APPLICANT:	<b>PDA Surveyors Engineers &amp; Planners obo G Blackberry - PA\26\0062</b>
PROPERTY ADDRESS:	<b>139 Ritchie Street WESTBURY (CT: 29482/38)</b>
DEVELOPMENT:	<b>Subdivision (3 lots), single dwelling, residential outbuilding (garage), removal of dam &amp; rainwater tanks (3) - setbacks, lot design, frontage, driveway, traffic, waterway.</b>

## 139 Ritchie Street, Westbury

**PROPOSED DWELLING**  
**LOT 2, 139 RITCHIE STREET,**  
**WESTBURY, 7303.**

**RE: 139 Ritchie Street, Westbury – 3 Lot Subdivision: RFI Response 09<sup>th</sup> September 2025**

**DRAWING**  
**SITE PLAN**

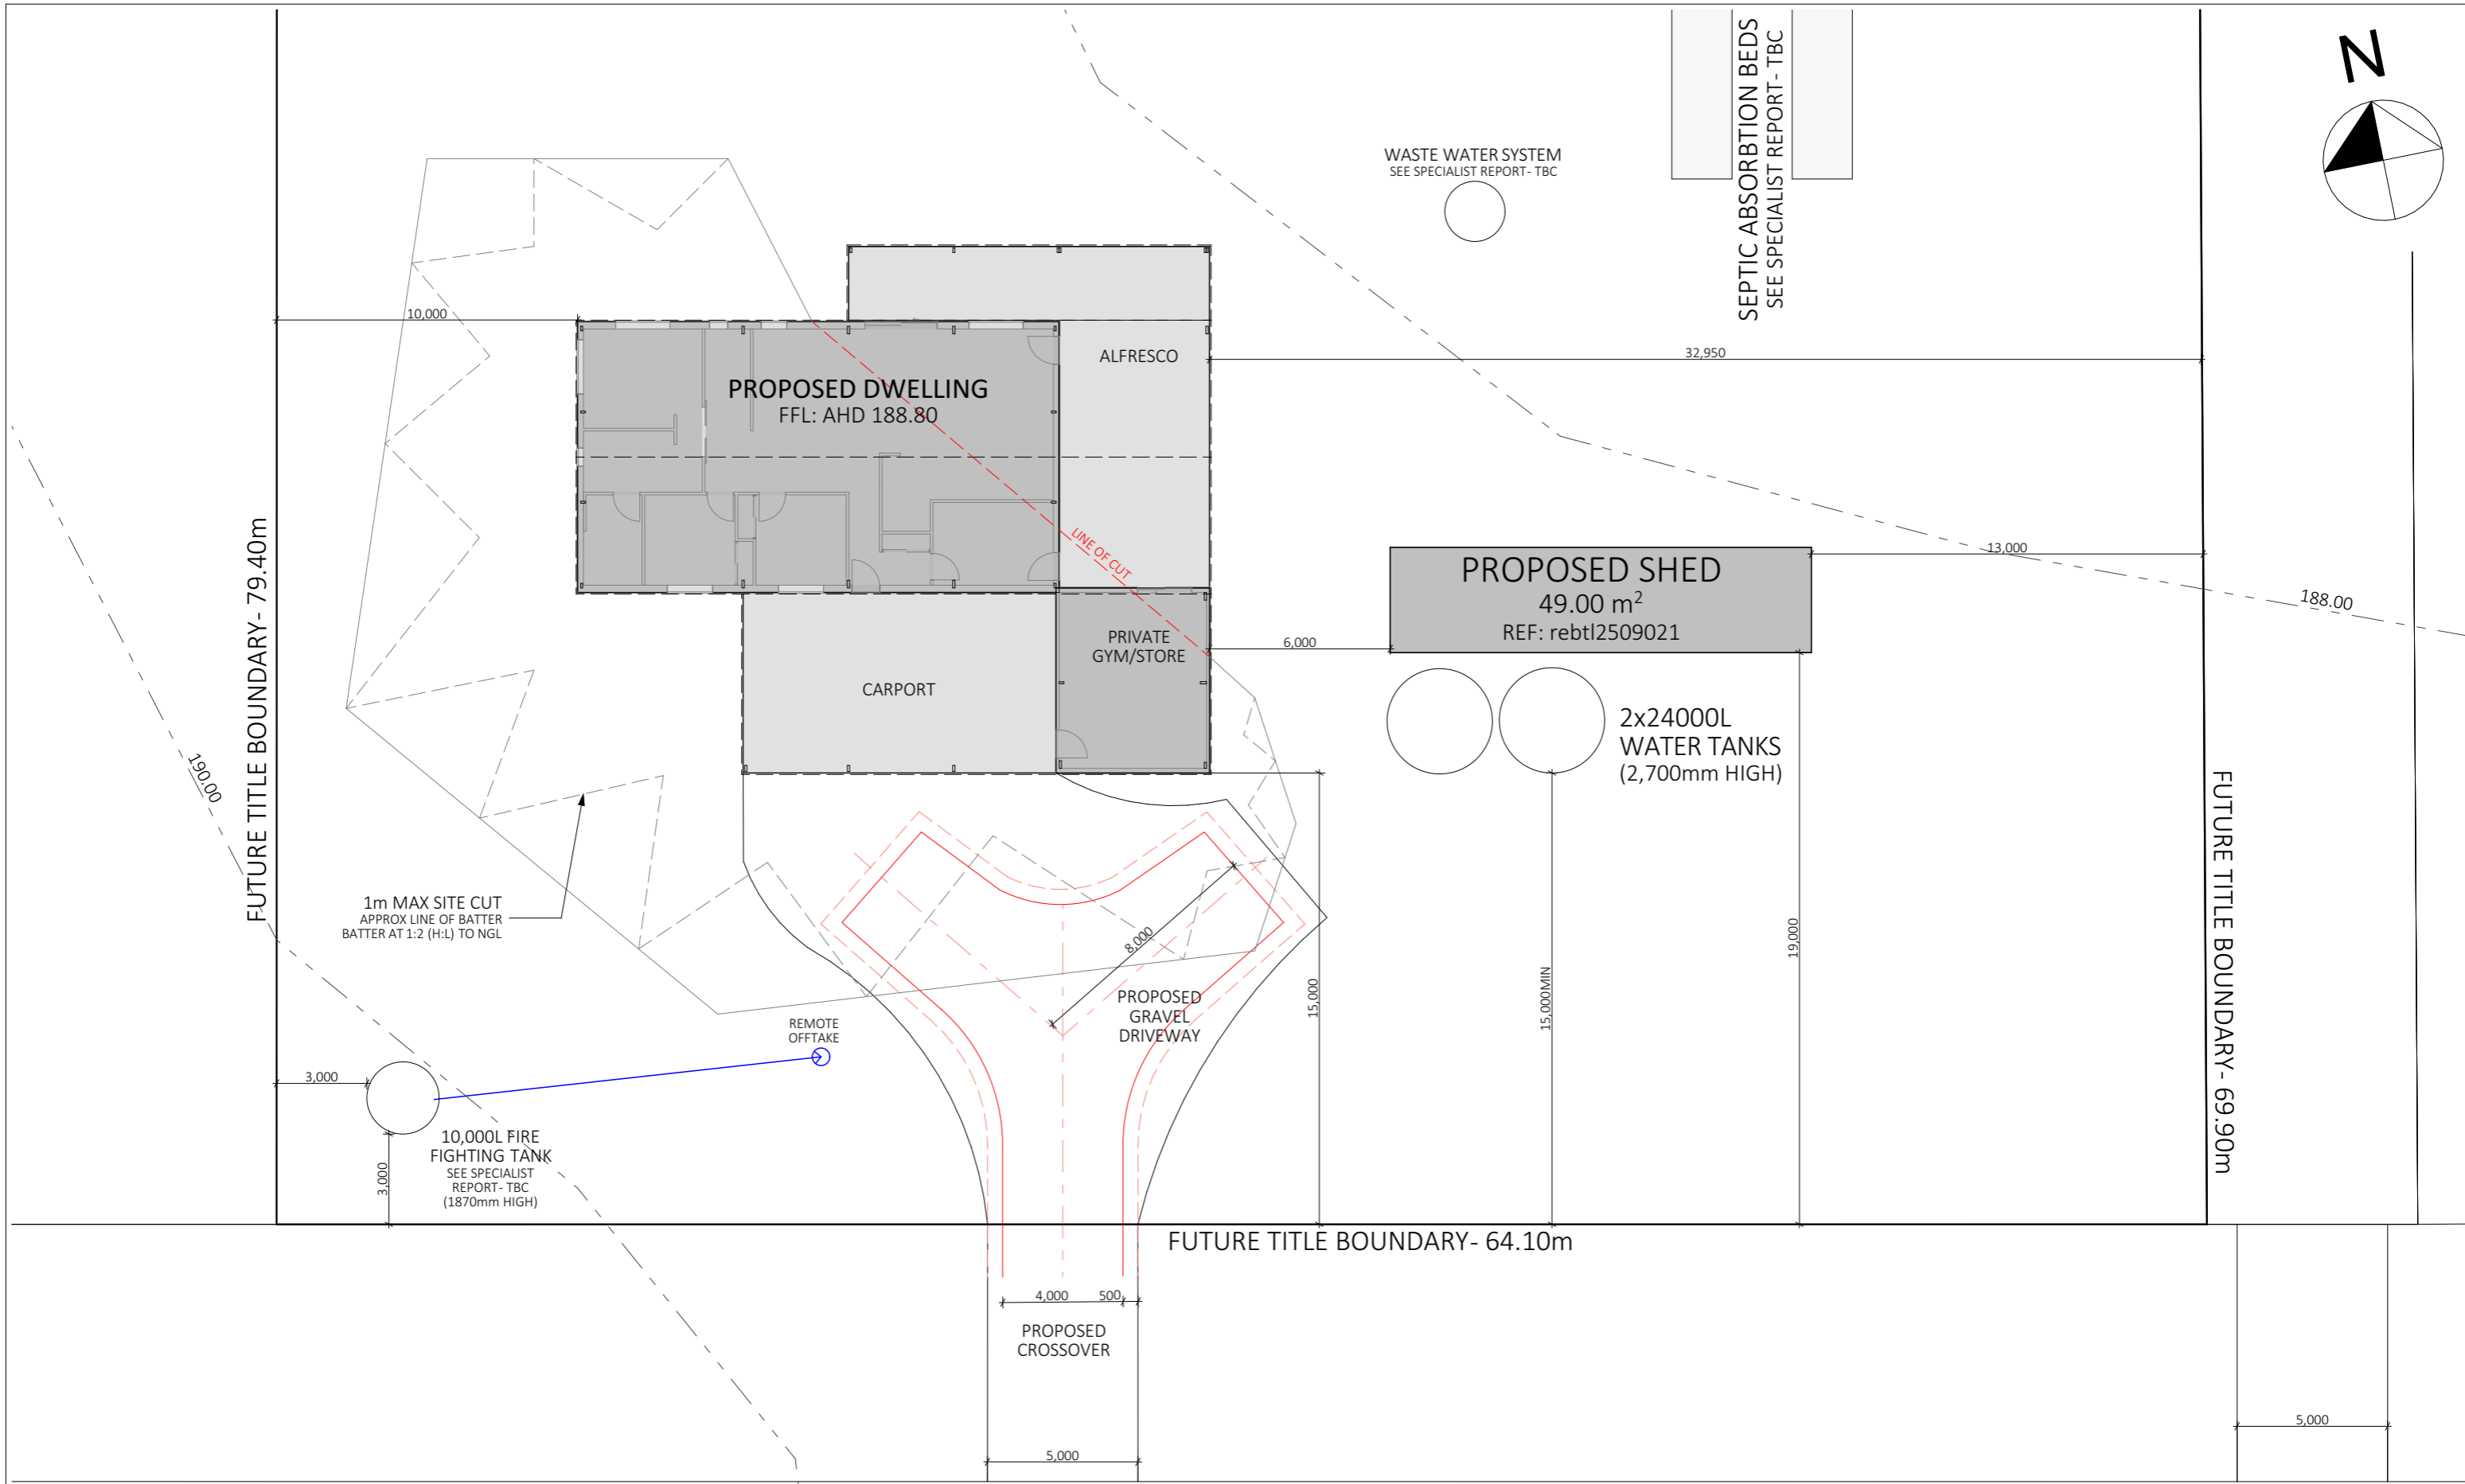
- 2. Please amend the Location Plan to show all rainwater tanks, with setback distances to boundaries and dimensions (including overall height)**

Figure 1. Dam depth from LIDAR

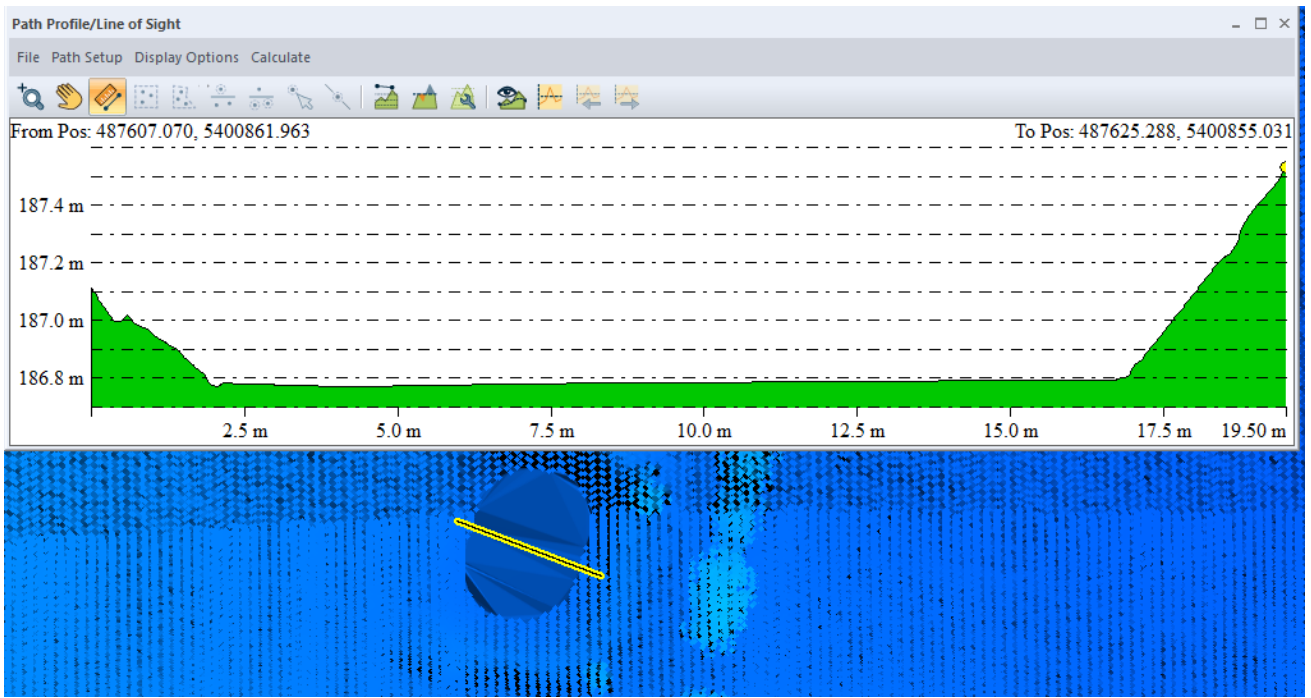
- 3. Details on the existing dam and the proposed filling of this dam. When was this dam created? Please show the existing intake and outfall of the dam. How is the dam to be drained? Will the land be reshaped, if so, please provide details, including the flow of surface water. Please address Code C7.0 Natural Assets Code.**

The dam shouldn't be considered a water course as class 4 watercourse is a watercourse that carries water for part of wall of the year for most years. Per the image below the flood overland hazard map shows no flow coming from the dam so therefore doesn't provide any flow. Flows from the site shouldn't determinate any person as future works will require collection of rain and additional cut of drains can be utilised for new access for the lots.
